RE: Lost Creek ISR LLC, In-Situ Recovery (ISR) Permit Application, TFN 4 6/268, 3rd Round Technical Review Comments

File: Lost Creek ISR, LLC Uranium Project, Permit Application, TFN 4 2/628

Subject: Third round of Technical Review comments on Lost Creek ISR Application,
TFN 4 6/268

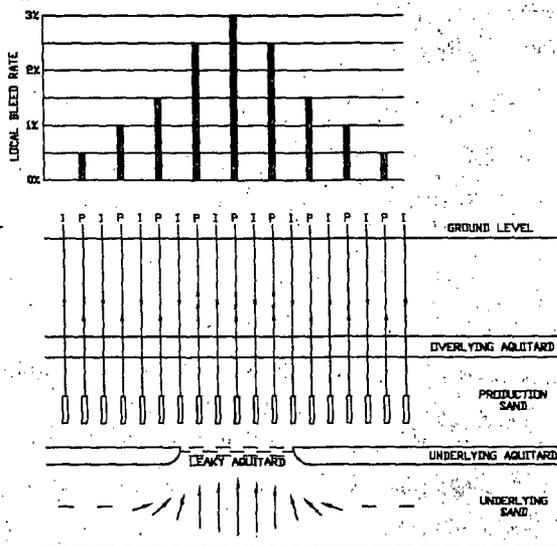
LQD (11/09) - Response not acceptable. *Section OP 3.6.3.3 still states that the "LC ISR LLC will apply for a permit revision to conduct ISR in the overlying FG and underlying KM sands" If it is known that these units will be mined, then appropriate baseline studies must be conducted prior to any mining, which would likely result in disruption of the baseline conditions. If mining in these units is not anticipated, then the statement in Section OP 3.6.3.3 should be dropped. (AB and MM)*

LC ISR, LLC (2/10) - The reference to mining in other sands has been removed from Section OP 3.6.3.3.

LQD (3/10) The reference to future mining in the KM sands has been removed, therefore at this point in the permitting process, the sand underlying the KM does not require baseline analysis. Prior to any mining in the Km, the underlying sand will need to be fully characterized. **This item is resolved.** (AB)
